LINCOLN PARK PLANNING COMMISSION

AGENDA

Conceptual Site Plan Review

Applicant	Channel Brawner, represented by Sketch Design Group, LLC
Project	Childcare Center
Address	1336 Southfield Road, Lincoln Park, MI 48146
Date	April 12, 2023
Request	Conceptual Site Plan Review

EXISTING SITE PLAN @ 1" = 10'-0"

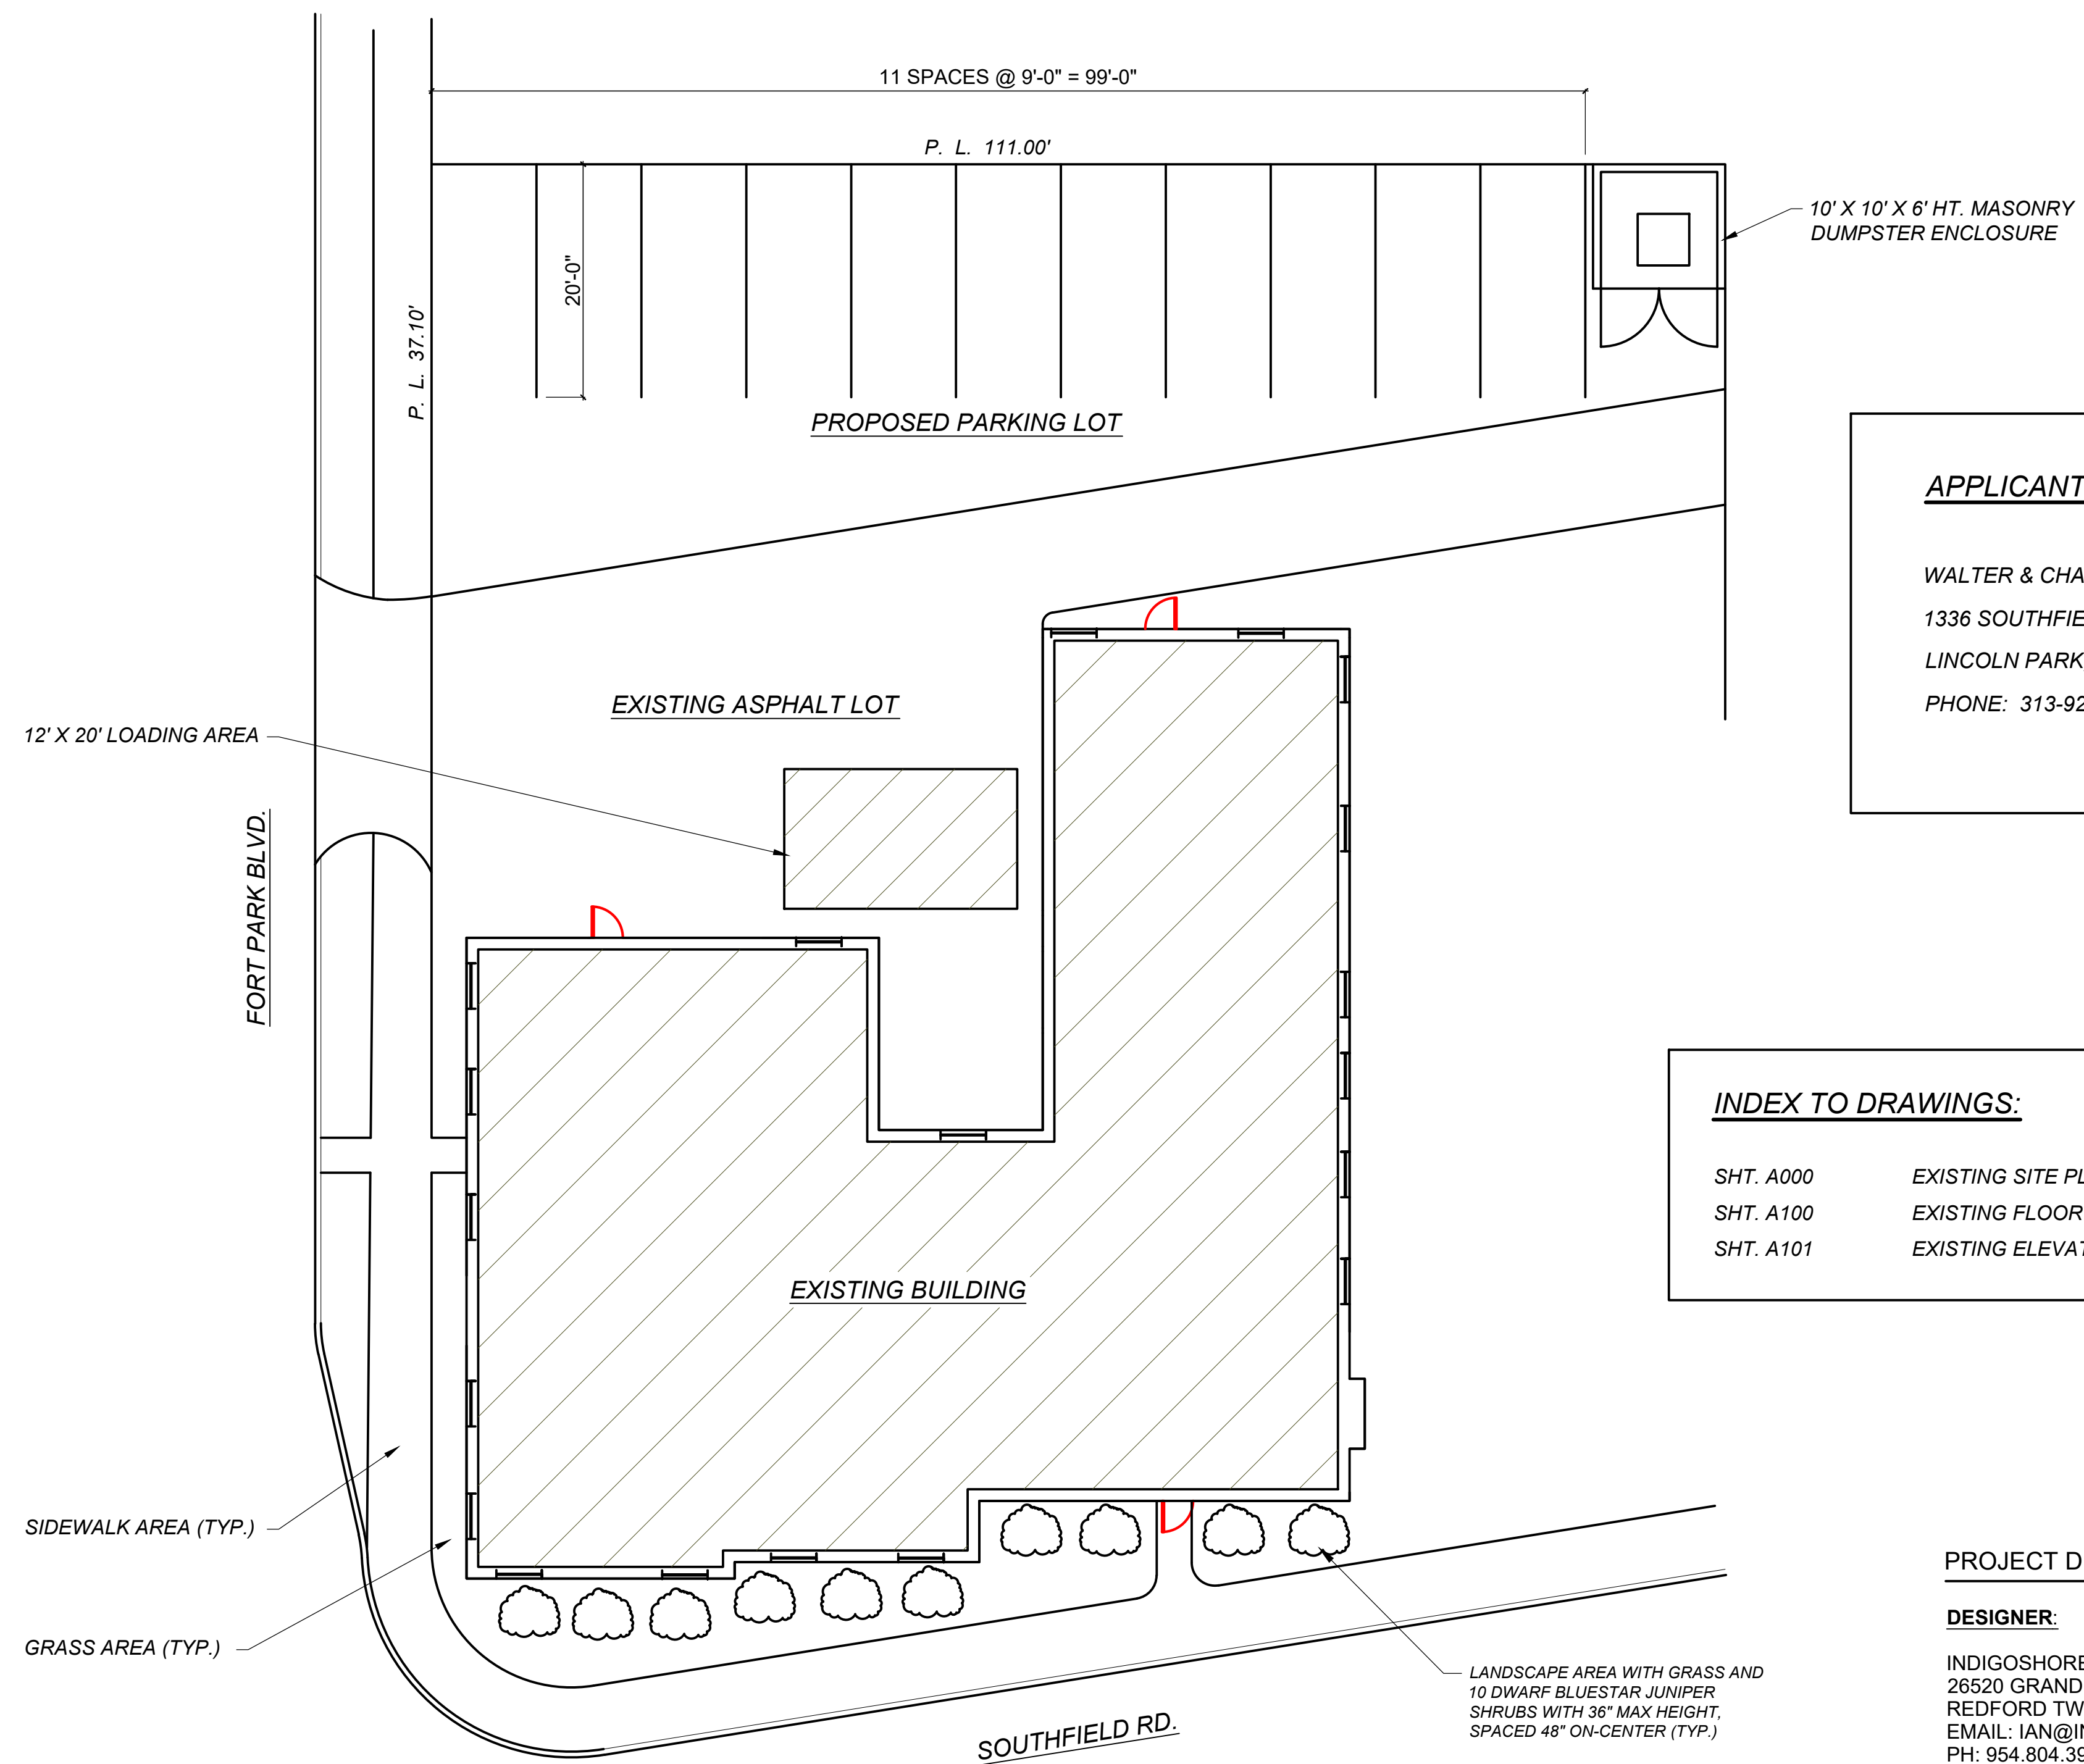
Required	Proposed	Compliance
Parking Area Type B §1290.05	Adequate means of ingress and egress shall be provided and shown	Ingress/egress provided on Fort Park Blvd.	Met
	Parking facilities, access drives, and maneuvering aisles shall be hard surfaced with concrete or plant-mixed bituminous material, maintained in a usable dustproof condition and graded and drained appropriately	No material details provided for the proposed parking lot.	INQUIRY
	Concrete curbs and gutters	No curb and gutter details provided.	INQUIRY

- Applicant shall provide surface material details on the proposed parking lot.
- Applicant shall provide curb and gutter details.
- Applicant shall provide the required 6' solid masonry wall, ornamental on both sides, with bumper guards, on the north end of the property line abutting residential property.
- Applicant shall provide a barrier between the parking area and the public sidewalk.

- Applicant shall provide four (4) additional trees to meet the street, interior, and parking lot landscaping requirements.
- Applicant shall provide the required 6' solid masonry wall, ornamental on both sides, with bumper guards, on the north end of the property line abutting residential property.

- Applicant shall work with the City Engineer to verify the existing water service and sanitary service type, size, and determine the lead capacity for the proposed building use.*
- It is highly recommended that the existing sanitary service be videotaped to determine the condition of the service lead.*

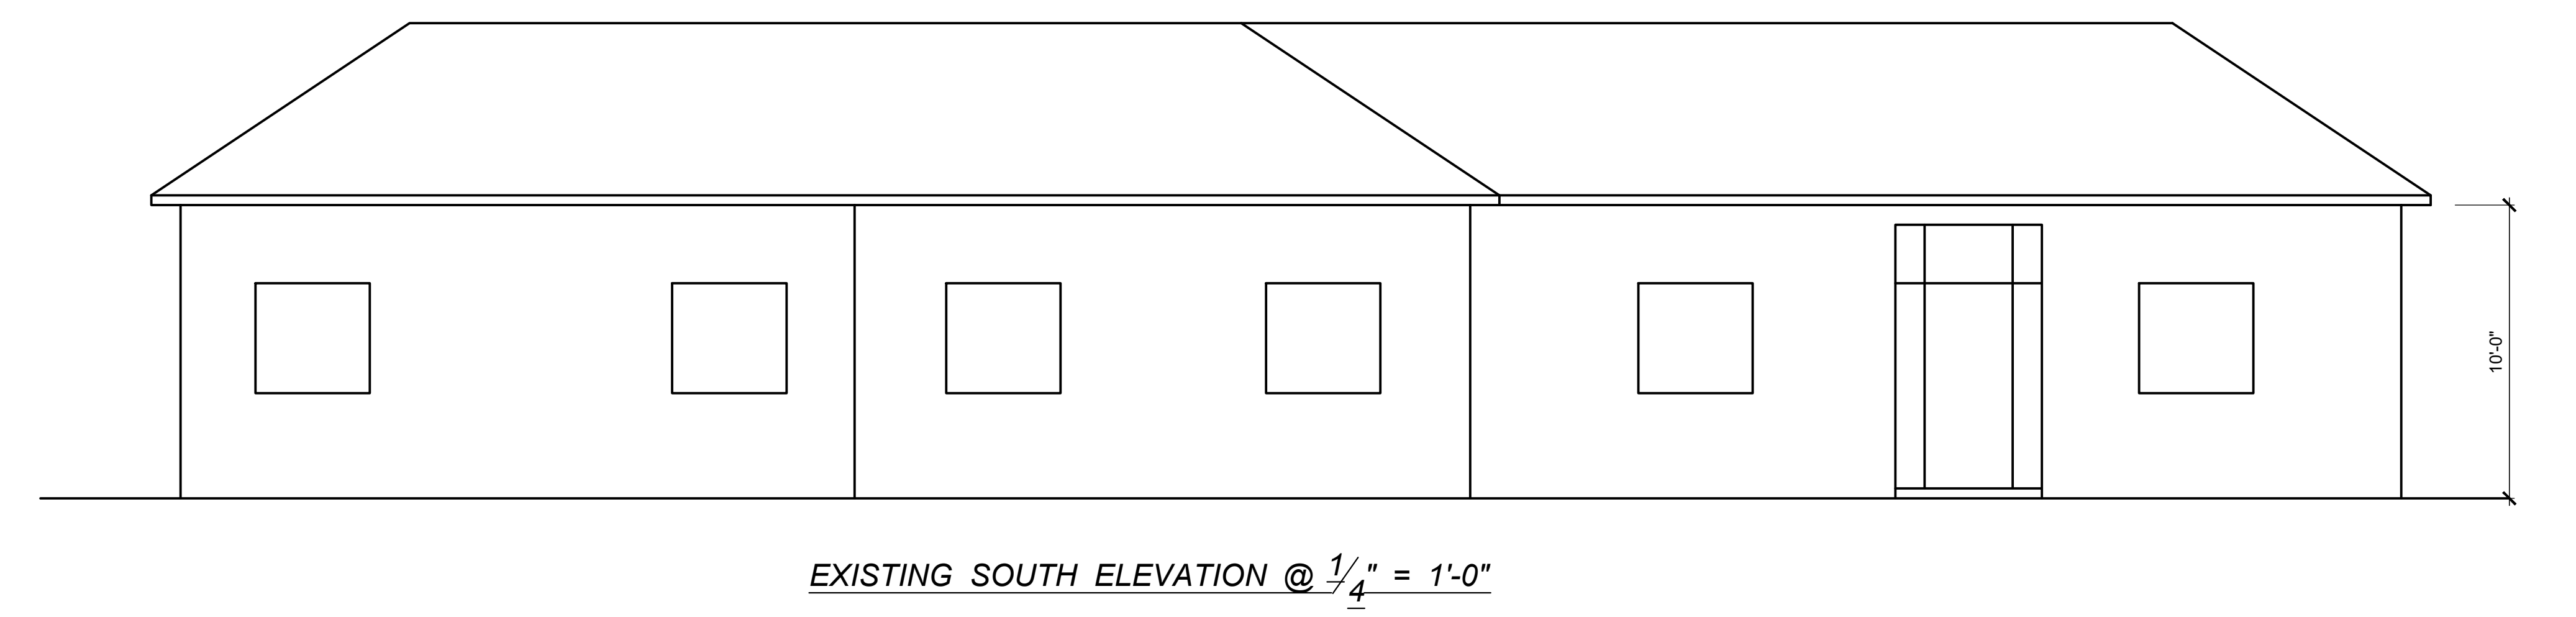
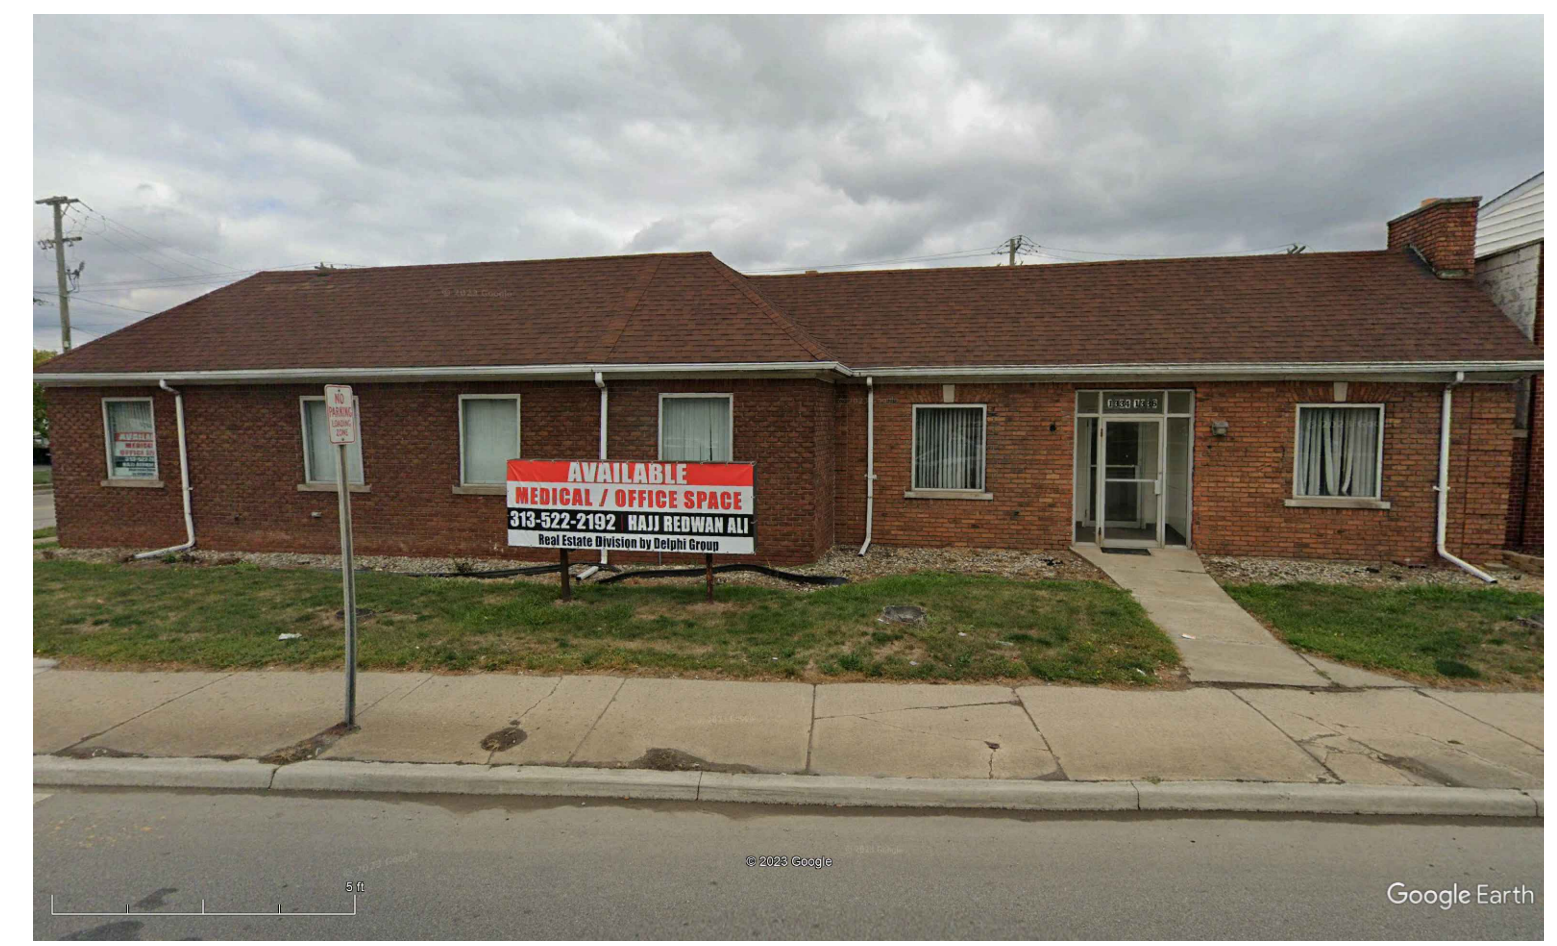
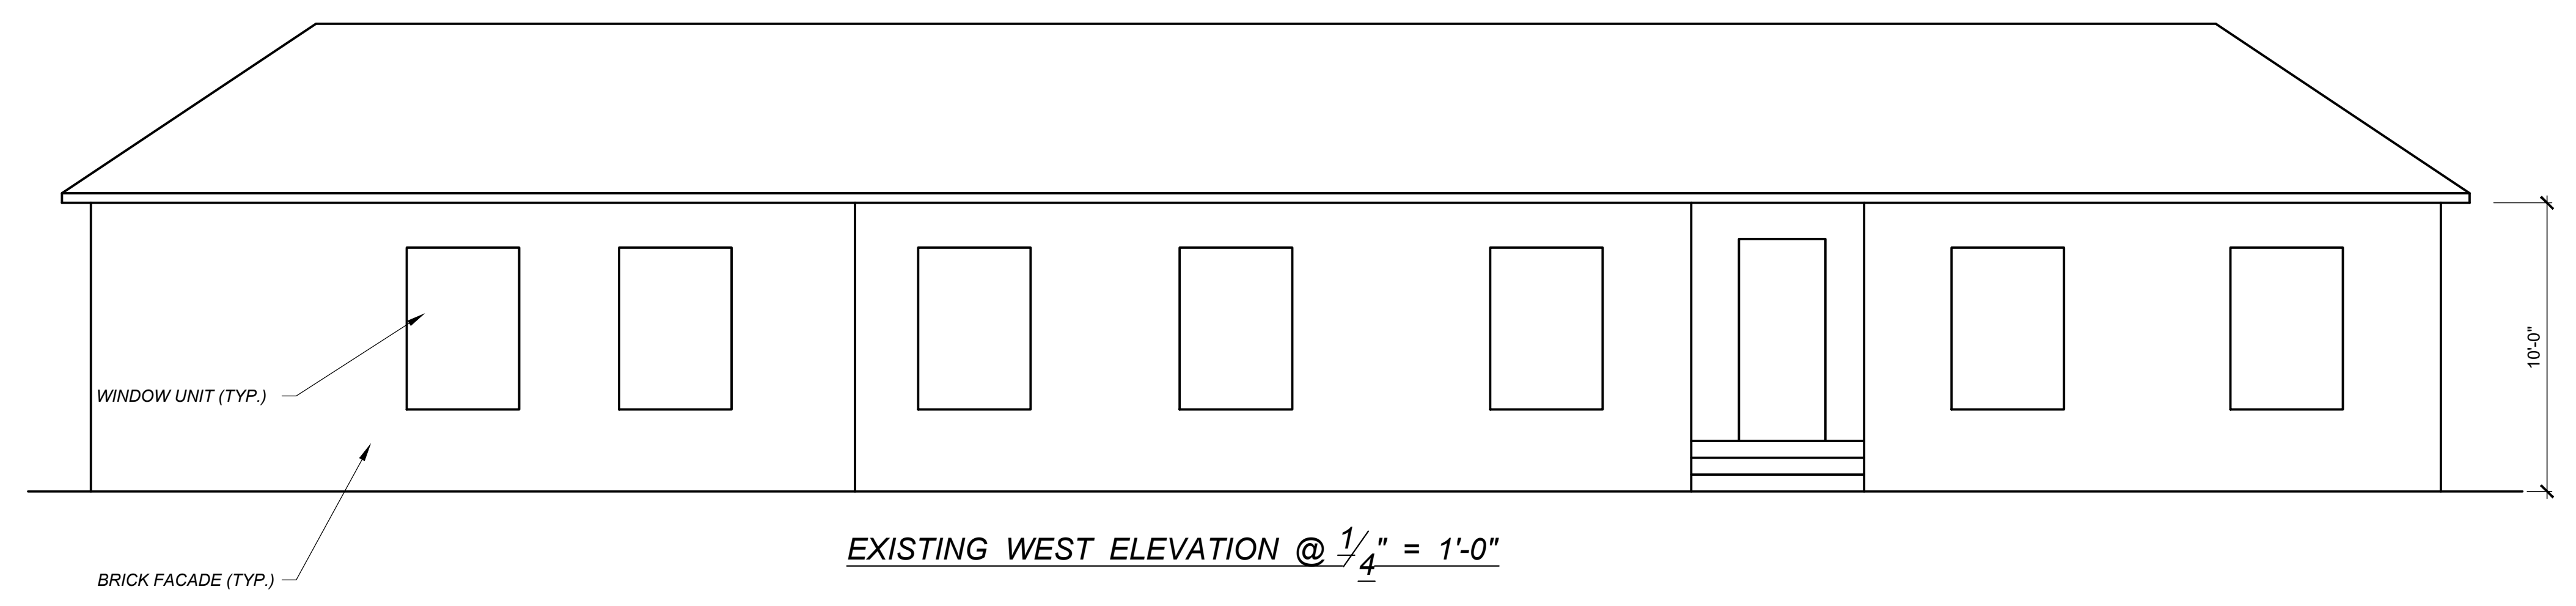
- Applicant shall provide elevations for the rear (north) side of the building.
